SERVICE BULLETIN

FUJI HEAVY INDUSTRIES LTD.

NO : FAS-052

1. SUBJECT : Improvement in Landing and Taxi Lights Installation.
2. AIRCRAFT AFFECTED : FA-200 Series serial Nos. 1 thru 101.
3. PRIORITY : Desirable.
4. REASON : In order to improve security and also to prevent possible crack of the subject lights, plates will be patched for channels.
5. DESCRIPTION : Plates to be patched and channels reworked.
6. ACCOMPLISHMENT : Optional.
7. APPROVAL : Not applicable.
8. PARTS REQUIRED : The following parts are required to perform the modification:

FIG. 1

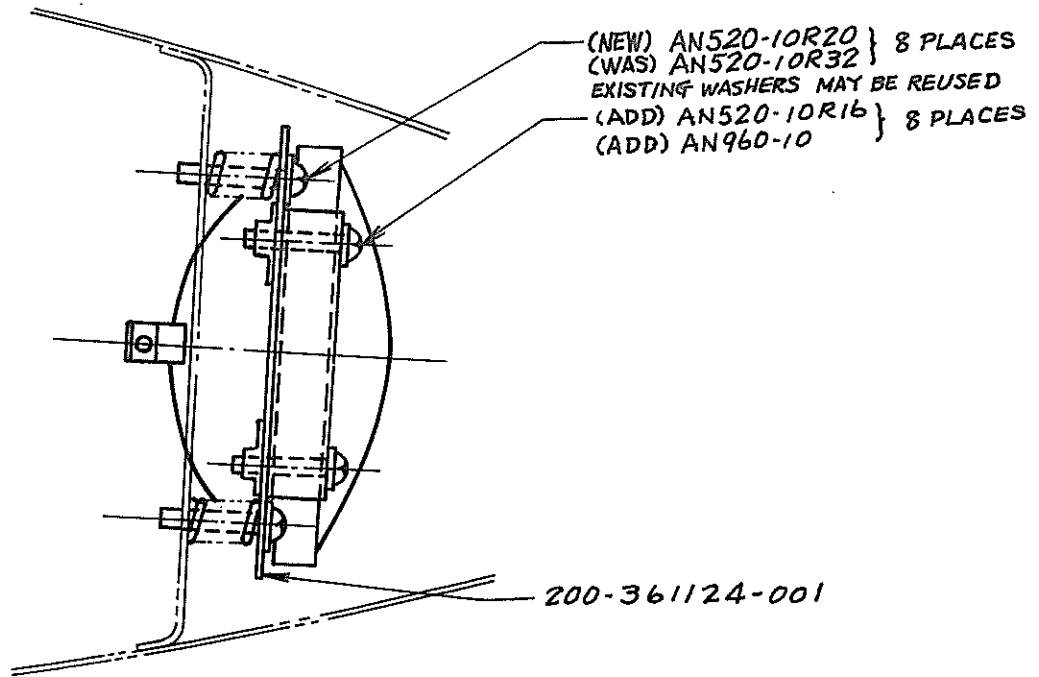
- (2) Back off screws and remove four channels attaching the two lights. Then pull forward the lights.
 - (3) Separate harness from the lights.
 - (4) Install two plates, 200-361124-001, in positions as illustrated in figure 1.

- (7) Connect harness to the landing light and to the taxi light. Install the reworked channels to the plates with eight screws, AN520-10R16, and eight washers, AN960-10. See figure 1.

FIG. 3

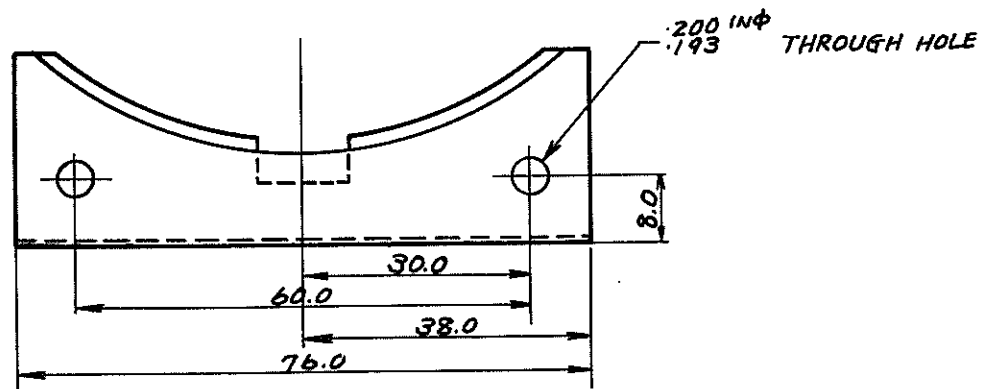
- (5) Adjust attaching angle of the above two plates in accordance with Service Manual, para. 10-9-1, "Angle Adjustment for #102 and subsequent."
 - (6) Rework four attaching channel, 200-361123-003, to dimensions shown in figure 3.
